Statement of Environmental Effects

S.96(1A) Application to modify Project Approval 06/0191

Orica Southlands Remediation and Warehouse Project

Port Botany Industrial Estate, McPherson Street, Botany

Figure 3 - Proposed Site Plan

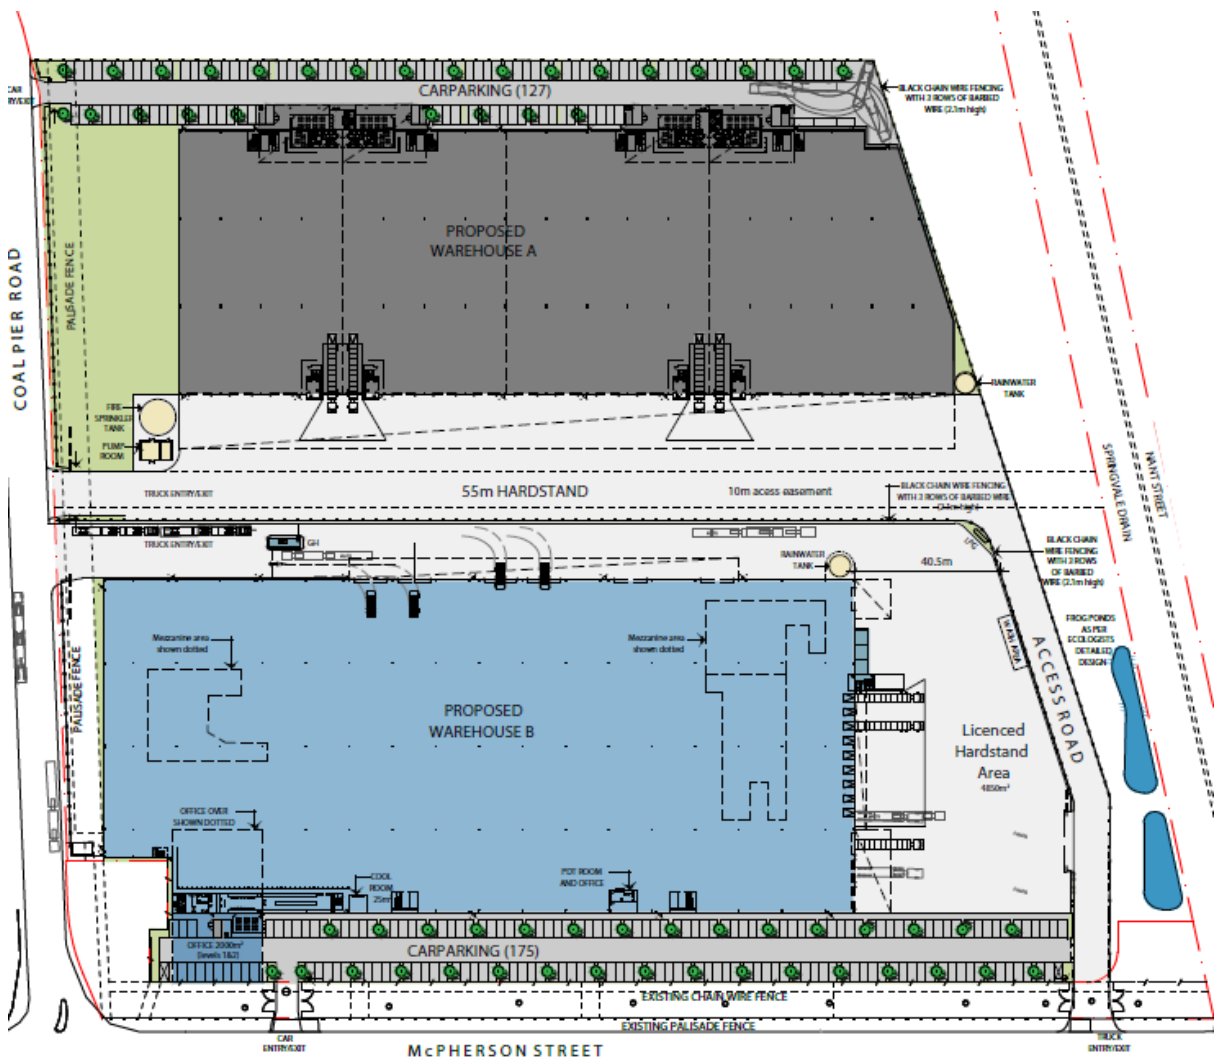
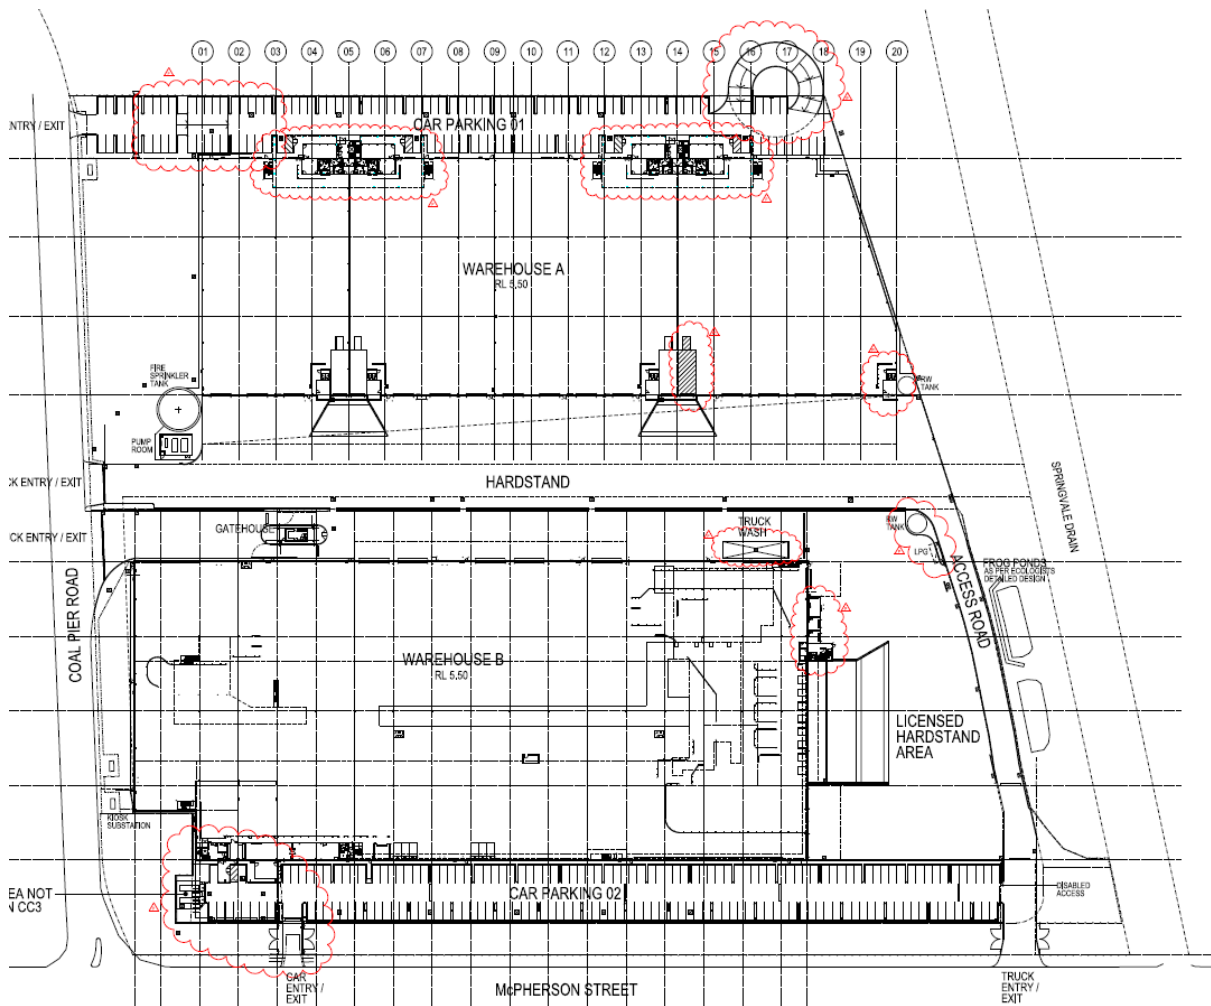
The proposed S.96 modifications are minor and are shown clouded in red in the following plan:

This S.96 application seeks the following changes to the approved design of Warehouse A & B on the site:

Figure 5 - Proposed Car Parking Layout and Turning Head for Warehouse A

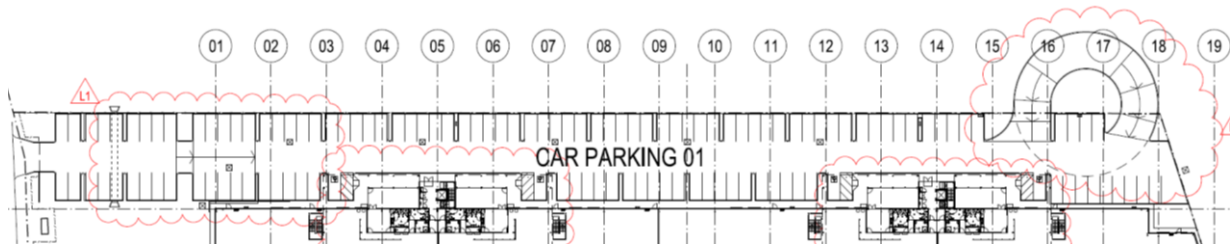
- + The NSW Fire Brigade have confirmed a turning head is required in the North Eastern portion of Warehouse A's car park. This is required to enable fire trucks the ability to turnaround to exit the site in a forward direction (refer to Figure 4 & 5 below).
- + Civil Engineers, Costin Roe, have confirmed that the design of the turning head in the supplementary civil plans (**Appendix B**) which protrudes into the flood basin, will not have any impact on approved flood storage for the site (refer to **Appendix C**, and Section 4.3 below).
- + The turning head has a radius of 14.7m, adequate to accommodate emergency and garbage trucks.

- + The car parking layout has been modified to make allowance for the proposed turning head, the provision of which will necessitate a reduction of two car spaces, from 127 to 125 spaces.
- + Despite this reduction in car spaces, Warehouse A continues to provide sufficient car spaces as required by tenants and in satisfaction of that required in accordance with City of Botany Council DCP 2013 (which requires a minimum of 91 car spaces (refer to **Section 4.4** below).

Figure 6 - Proposed additional drainage outlet

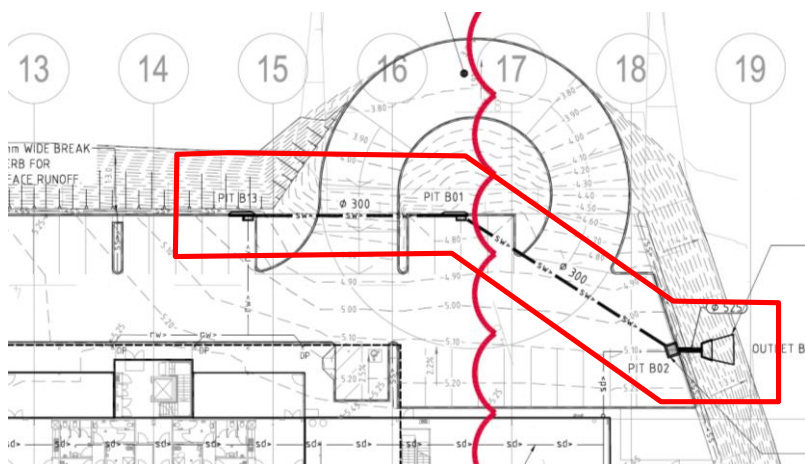
- + An adjustment to the approved drainage layout along the north eastern side of Warehouse A is proposed (refer to Figure 6 below). This includes the addition of a drainage outlet running in an easterly direction in the area of the turning head (refer to **Appendix B** for plans).
- + This proposed adjustment is necessary to limit works within the constructed Springvale Drain and associated floodway, reduce any impact of the turning head, and the extent of works required within contaminated land.
- + The adjusted design remains consistent with the approved stormwater management strategy defined in the approved documents (refer to **Appendix C** – Costin Roe letter, dated August 2015).

Figure 7 - Approved Warehouse A Office Mezzanine - Proposed for Removal

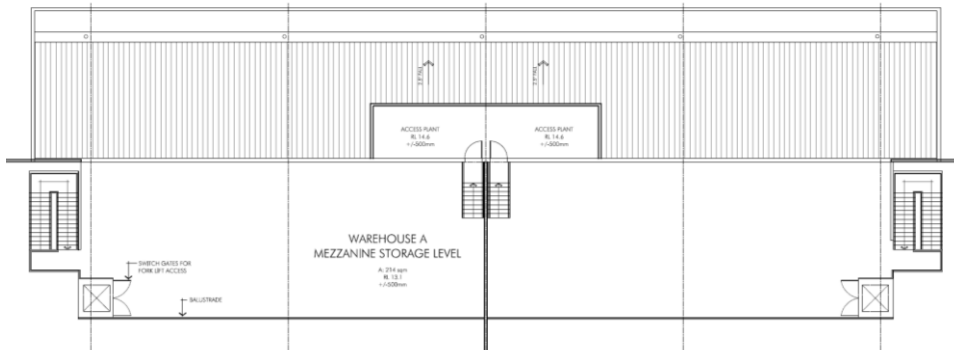
- + The mezzanine storage areas above the first floor office (drawing 4244_DA-16 in the approved set), is proposed for removal, resulting in an aggregate reduction of 964 m² of gross floor area.
- + This storage area is proposed for removal as it is not required by the tenant.

Figure 9 - Proposed new location for dock office in the south eastern corner of Warehouse A

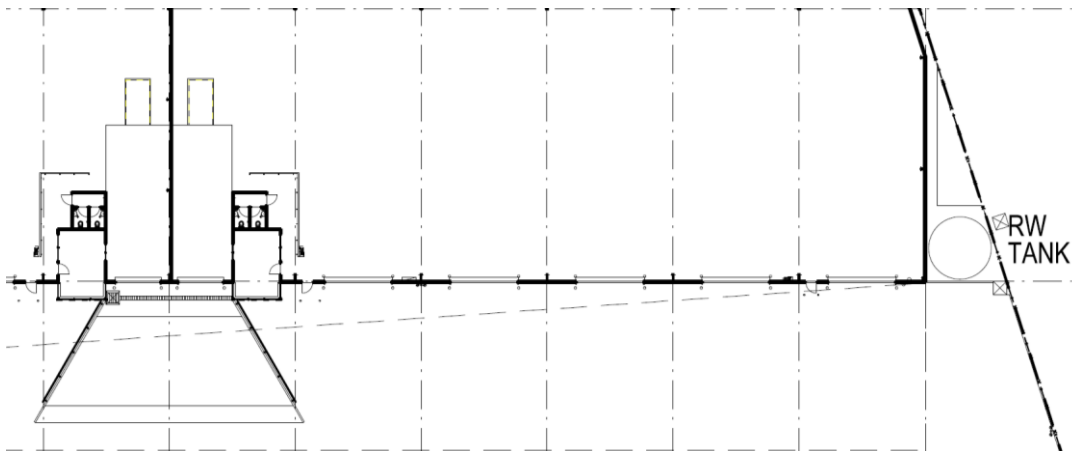
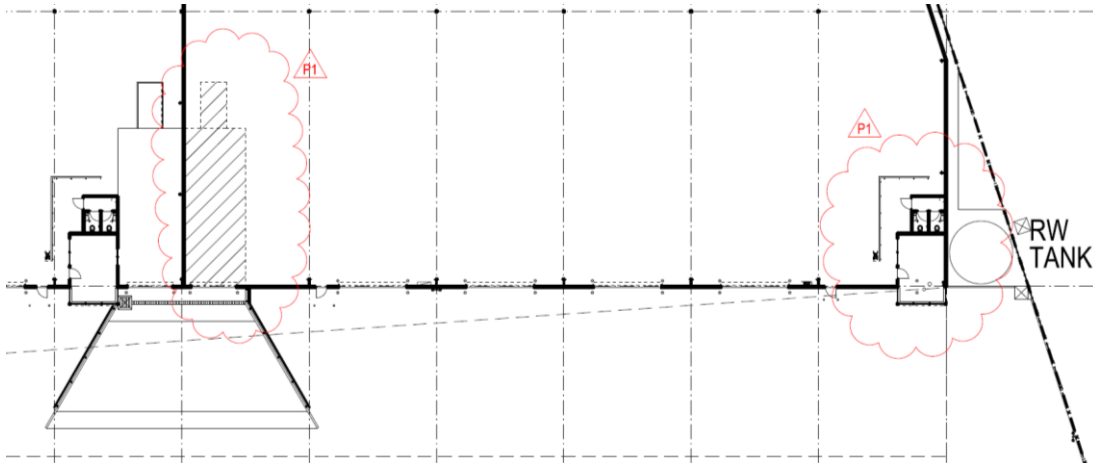
- + Movement of a dock office from the recessed dock to the south eastern corner of the warehouse building.
- + This will provide enhanced layout and enhanced access for staff at the corner of the building.

Figure 10 - Approved Warehouse B Dock Office layout

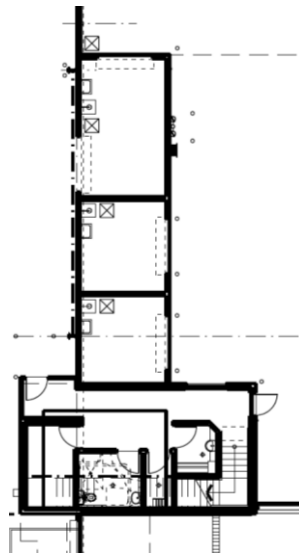
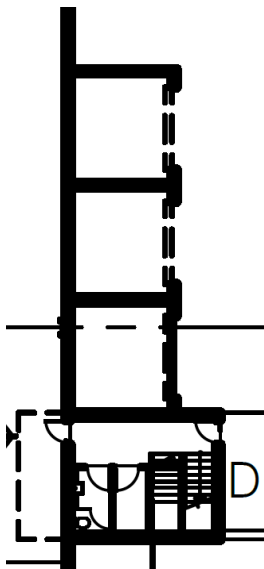
- + The layout and area of Warehouse B's control tower, located in the northeast corner of Warehouse B, is proposed to be modified slightly.
- + The floor area of the control tower is to be increased by has been increased by 40m² from 58m² to 98 m². (Refer to **Appendix A**, drawings GA-302, 306 & 319).
- + The proposed modification to size and layout of the dock office will enhance the use to better suit the tenant's needs.

Figure 11 - Approved Truck Wash and Rainwater Tank Location

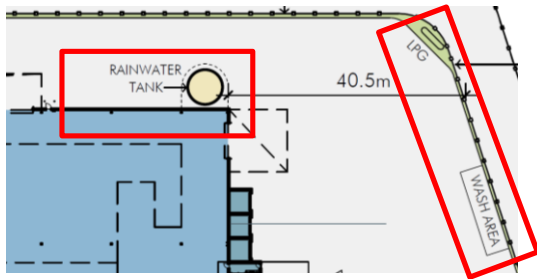
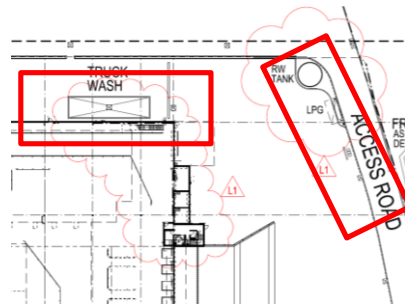
- + Warehouse B's rainwater tank is proposed to be relocated from the North Eastern corner of the building to the North Eastern corner of the site (refer to Figure 9 below). This proposed relocation will provide for enhanced layout and better vehicular flow around the warehouse.
- + The LPG gas storage area is proposed to be moved slightly north to make allowance for the rainwater tank relocation. A 6m X 3m awning is proposed to the LPG gas storage area. (Refer to **Appendix A** - drawings GA-101, 102, 113 & 380.) This awning will provide weather protection for the gas storage area and will have no impact to the surrounds.

- + The approved truck wash location is proposed to be relocated from the North Eastern corner of the site to along the North Eastern corner of Warehouse B.
- + The proposed relocation of the truck wash will allow for enhanced truck access and drainage arrangements for this wash area.
